SHEPLEY HILL LANDFILL SUPPLEMENTAL INVESTIGATION WORKPLAN ADDENDUM

REVISION 1 TO THE FINAL WORKPLAN DATED JANUARY 2010

ATTACHMENT A - RESPONSE TO COMMENTS ON THE 10/30/09 SUPPLEMENTAL INVESTIGATION WORKPLAN

1

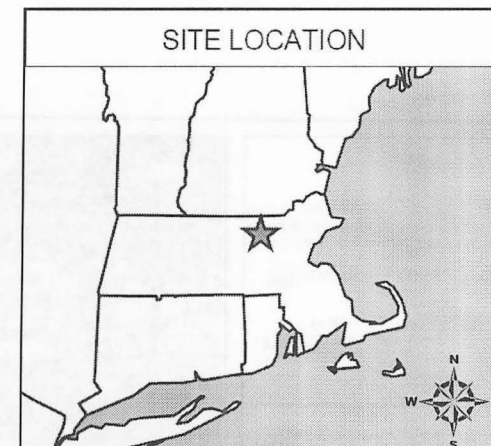
5. Page 6, Section 2.3, North Plume MNA for the Impacted Area: Relative to selection of proposed locations for "MNA Sampling", it is recommended that Figure 1 be revised to provide an overlay of existing and proposed well/boring locations with measured potentiometric surface for groundwater representative of the anticipated period for installation and sampling. This groundwater flow analysis should be used to develop a consensus regarding appropriate locations for the proposed soil and/or groundwater

According to Figure 1 of the Work Plan, only two borings are proposed in the down-gradient portion of the Impacted Area, one of which is located in the immediate vicinity of an existing boring. This effort seems insufficient to meet the stated goal of "delineating the north plume in all directions." To meet this goal, additional wells should be installed in several areas, including the following:

1. Page 6, Section 3.1.2.1: In addition to the geophysical survey lines presented on Figure 1, an additional line is needed south of Nonacoicus Brook, roughly parallel to the proposed line B-B’. The new line should extend from the DEP-08-05 area northeasterly to the vicinity of DEP-08-03, projecting along this orientation several hundred feet further to the northeast so as to intersect the green NW-trending forward particle tracks shown on the figure. Similarly, additional NNW-SSE trending alignments should be considered to better constrain the expected low, generally thought to underlie the brook area. In this respect, C-C’ should be

Response: A revised Figure 1 will be developed to show the modeled potentiometric surface and groundwater flow paths before and after implementation of the extraction system. We agree that conditions affecting MNA may vary significantly within the Impacted Area, and that further evaluation of existing data and field screening methods is appropriate to ensure that the tested materials are representative of the majority of the aquifer. As discussed in the Introduction to this RTC, we propose to conduct this investigation planning on a separate track from other Additional Work requirements so as not to delay those efforts; a schedule for this activity will be developed for discussion. Please see related EPA comment 9 part 2 and MassDEP comment 2 and the responses regarding identification of appropriate sampling locations.

Response: The eastern limit of the north plume in the area of SHM-99-32X is supported by earlier results from profiling at SHX-99-05 (1999) and monitoring at SHP-99-34 (2001). These results are not shown in the workplan Figure 1 because they are older, but they are included in the SAR (AMEC 2009) cross section Figure 4-3. In addition, the SGI included a detailed investigation of conditions along the West Main St. transect (see SGI Figure 3-26) which indicates arsenic detections along the eastern extent (the area due north of SHM-99-31 and SHM-99-32X) are neither contiguous with the main plume lobe nor strongly correlated with ORP. Because prevailing hydraulic gradients are westward in the Nonacoicus Brook valley fill aquifer, further investigation east of

**Figure 2 - Proposed Well Locations
Shepley Hill Landfill - Fort Devens
Ayer, MA**

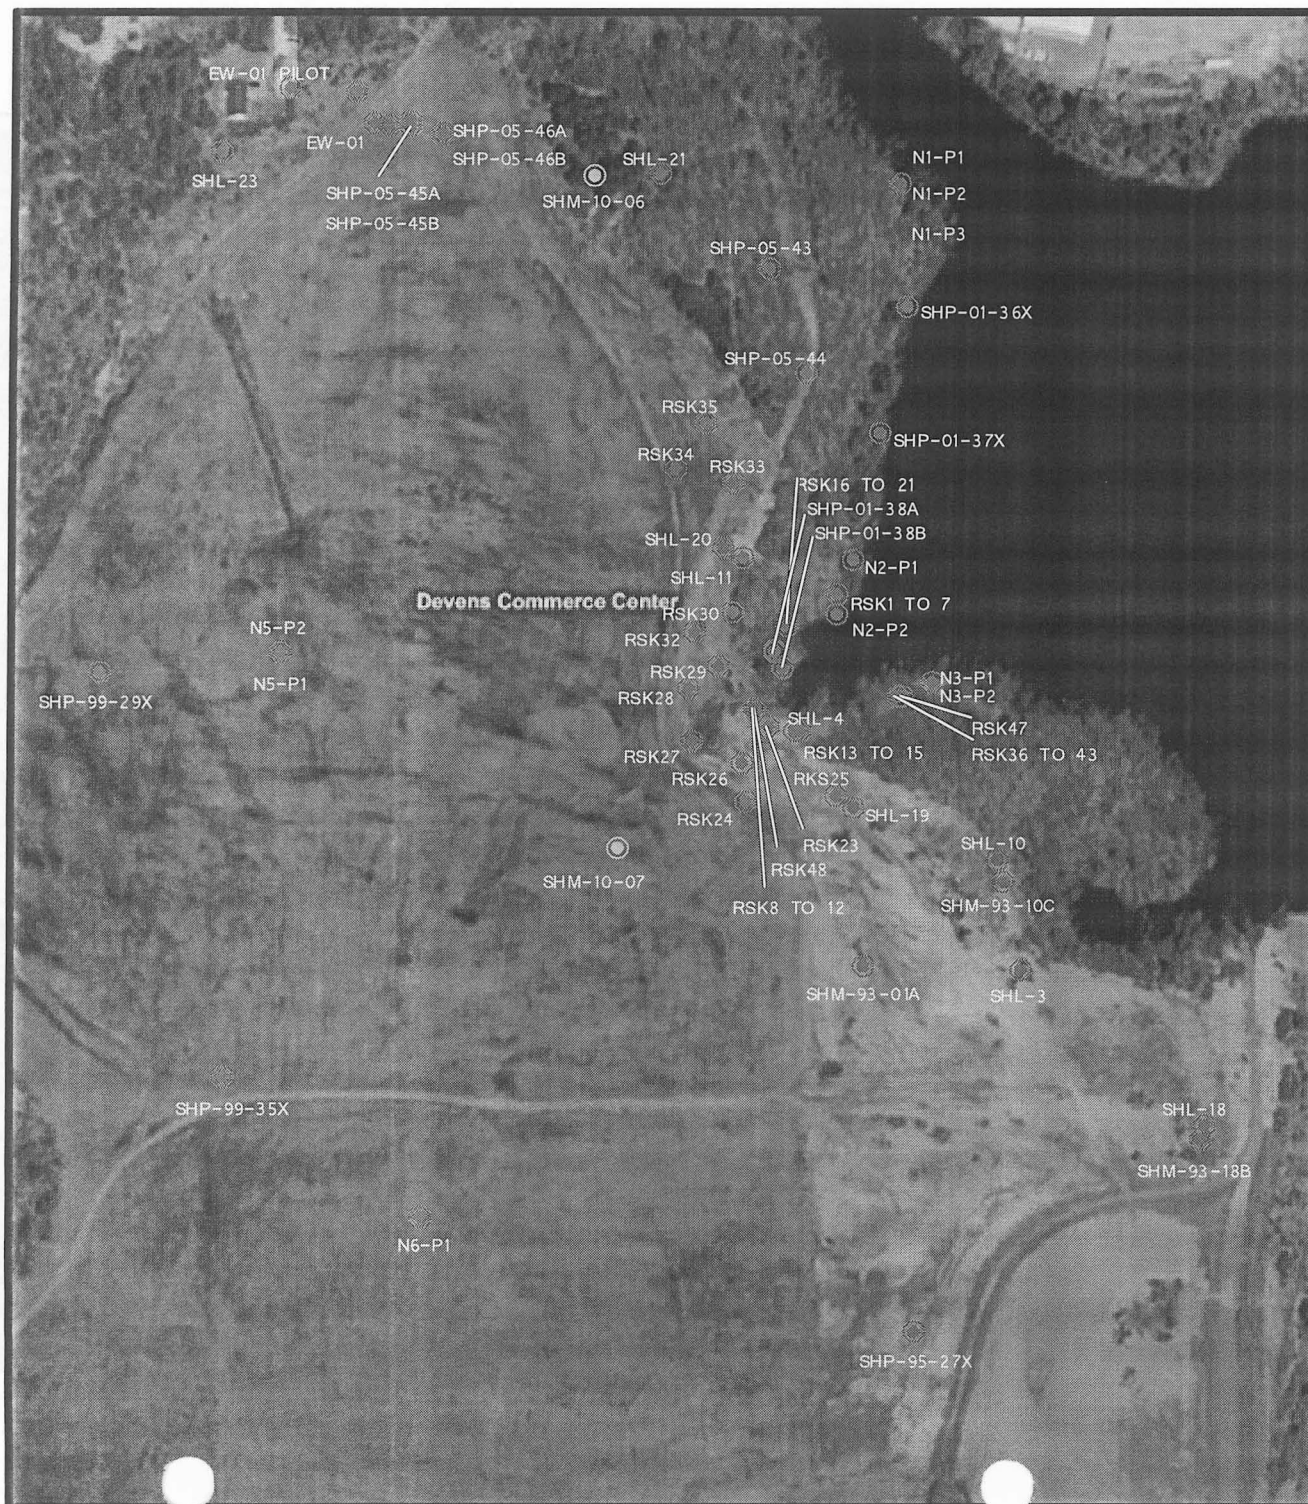
These well installations were proposed to evaluate horizontal and vertical plume dimensions in the area upgradient of the discharge to AOC 72. However, it was decided by the Army that one location would be completed at the location identified as SHP-10-07 on Figure 2. Information

wetland prior to filling", be graphically delineated in Figure 2. It is not clear to what area of the landfill this description applies.

Response: A revised Figure 2 will be developed as part of the investigation planning described above.
